This Service Information bulletin supersedes SI B54 04 14 **dated April 2014**.

E89 (Z4)

The wiring harness for the convertible top rear module sensor may be positioned incorrectly, which can cause damage to the wiring harness.

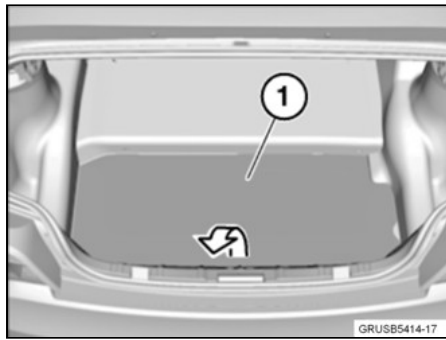
1. The areas to be worked on are highlighted by red circles.

Note: In this picture, the convertible top is in the service position with the rear module completely open. You can also perform this repair by opening the trunk.

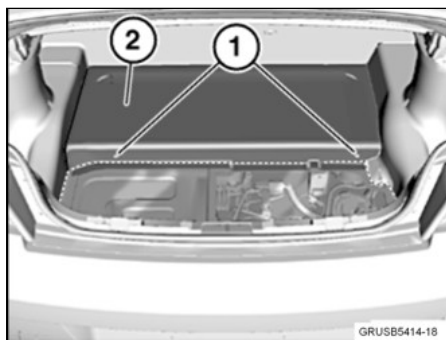
2. A closer view of the area that needs to be inspected is highlighted in red.

Note: The luggage compartment wheel arch panel must be removed.

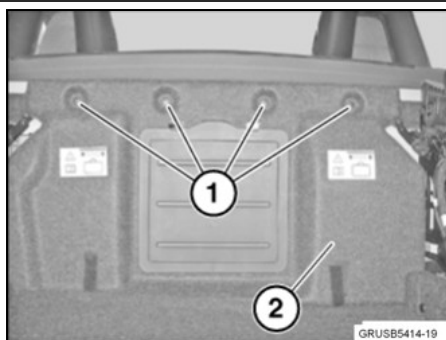
3. Remove the luggage compartment floor trim (1).

4. Pry out the expansion rivets (1).

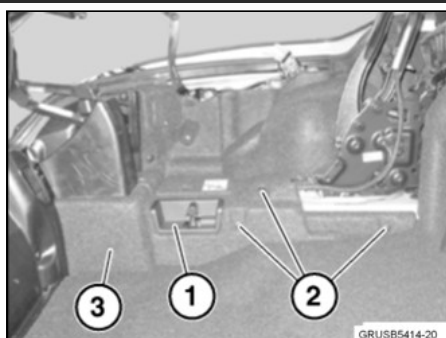
6. Pry out the expansion rivets (1).

7. Remove the panel for the luggage compartment partition wall (2).

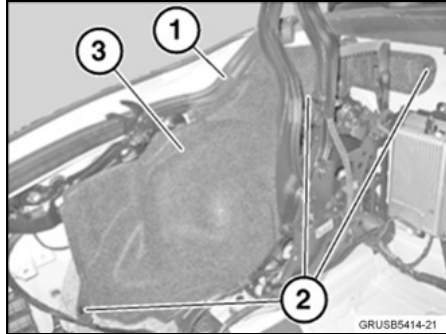
8. Unclip the trim (1).

9. Lift out the expanding rivets (2).

10. Remove the panel for the luggage compartment side member (3).
